TDECQ: main tap constraints

IEEE P802.3cd interim, Geneva, Switzerland, January 2018

Proposed text change for 139

Figure 139-5—TDECQ reference equalizer functional model

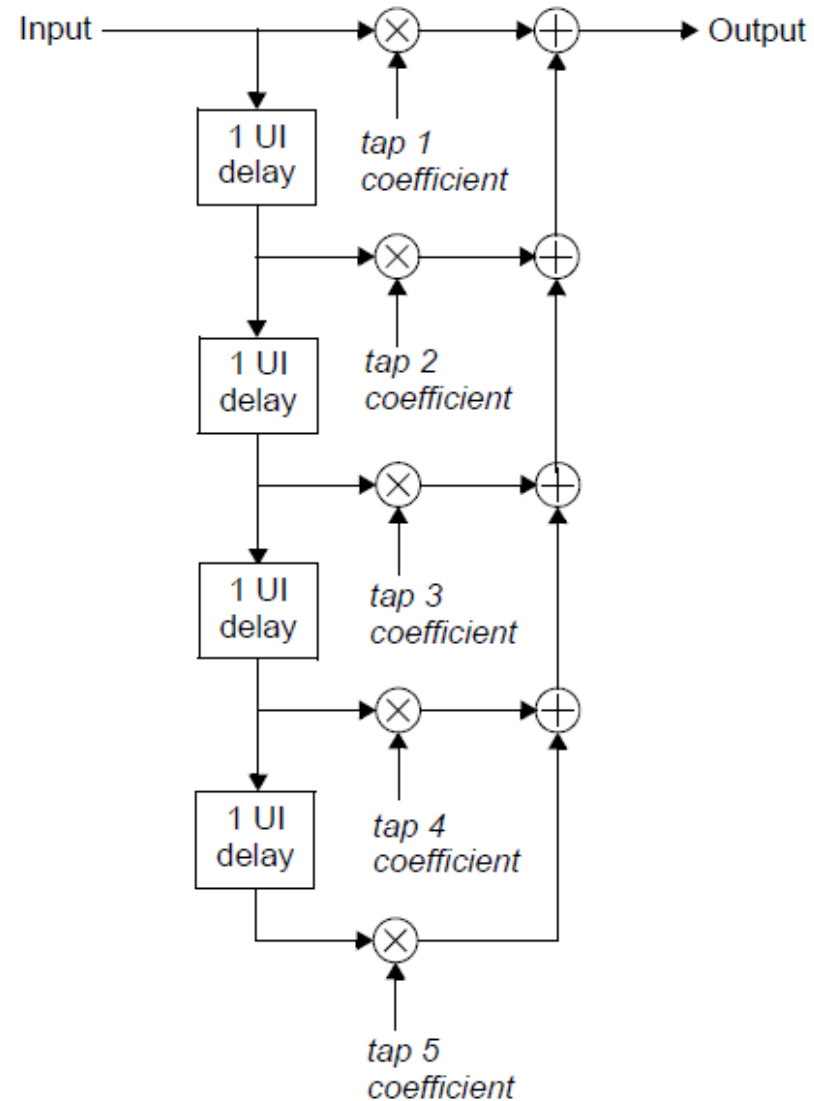
Add Figure 139-5 as shown next slide

TDECQ reference equalizer diagram to be added

The reference equalizer for 50GBASE-FR and 50GBASE-LR is a 5 tap, T spaced, feed-forward equalizer (FFE), where T is the symbol period. A functional model of the reference equalizer is shown in Figure 121–7. The sum of the equalizer tap coefficients is equal to 1. The largest magnitude tap coefficient shall be for tap 1, tap 2, or tap 3.
